**DEVELOPMENT SERVICES**  
ENGINEERING DIVISION  
156 S. BROADWAY, SUITE 150  
TURLOCK, CA 95380

**City Project No.:** 17-55

**Addendum No.:** 1

SITE PLAN  
CAPITAL PROJECT NO. 17-55  
FIRE DEPT LIVE  
FIRE TRAINING - PAVING

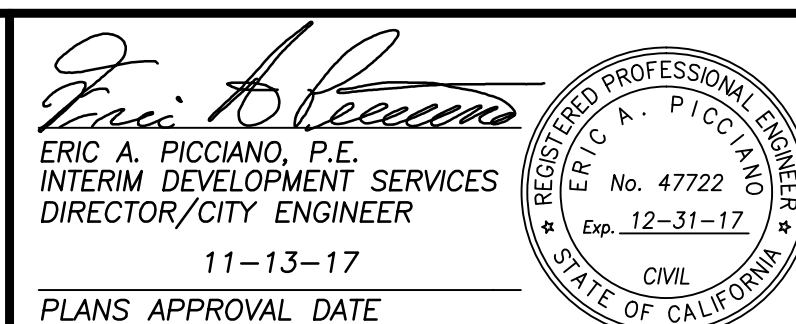
- Q. Is this existing catch basing going to require alteration I though the plans called for installing one?
  - a. Instead of installing a catch basin an existing basin that is at approximate elevation of street.  
It needs to be lowered to match the new slope.
- Q. On the plan set there is a call out to remove and replace concrete is this correct?
  - a. The concrete to be removed is to be replaced with hot mix asphalt.
- Q. Is there survey elevations for the footing?
  - a. There isn't an existing survey of the footing giving elevations.
- Q. Is there space available onsite to place removed demolished concrete and asphalt?
  - a. Demolished concrete and asphalt are to be removed from the site.
- Q. Are we going to use existing base footing for grading?
  - a. Grading is to be based on existing road and concrete footings.

Please find the attached Pre-Bid attendance sheet. Please find revised plan sheet showing corrections from questions.
